In the Matter of an application for approvals by
Matakanui Gold Limited to establish,
operate, rehabilitate and ultimately
close an open pit and underground
gold mining operation known as the
Bendigo-Ophir Gold Project

**Statement of Evidence of
Ryan Oliver Burgess on behalf of
Matakanui Gold Limited in response to
Section 53 Feedback
Mine Water Management**

Dated: 17 April 2026

Figure 1: RAS Pit Lake conceptual groundwater model.

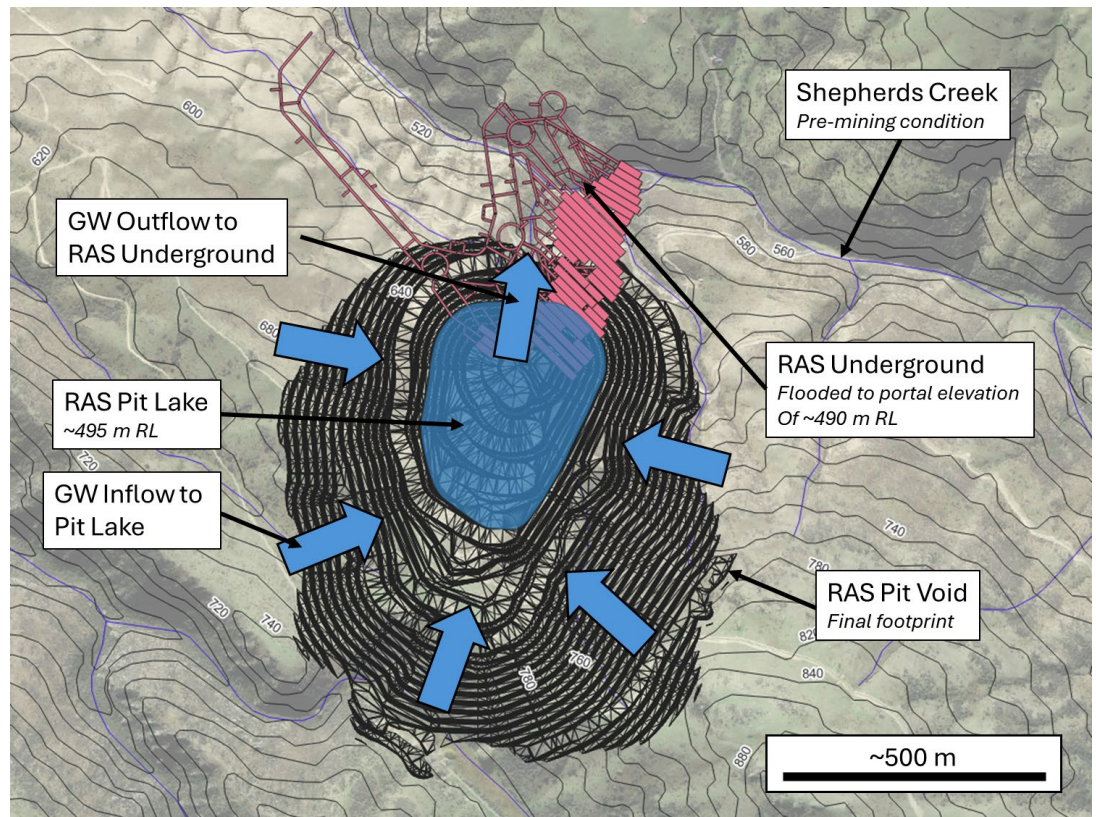
Comment: In paragraph 26 of her statement of evidence, Dr Webster-Brown comments that the RAS and SRX pit lakes are connected to groundwater.

87. Figure 1 presents a conceptual interpretation for the RAS Pit Lake. The flooded RAS Underground provides the downgradient lower hydraulic head of ~490 m RL, while the pit lake level will stabilise at around 495 m RL (MWM, 2026). The remainder of the pit perimeter is interpreted to have inward groundwater flow. Figure 10 of B.03 supports this interpretation with pre-mining groundwater levels well above 495 m RL near the RAS Pit. In conclusion, the risk of RAS Pit Lake water not being collected for treatment is low.
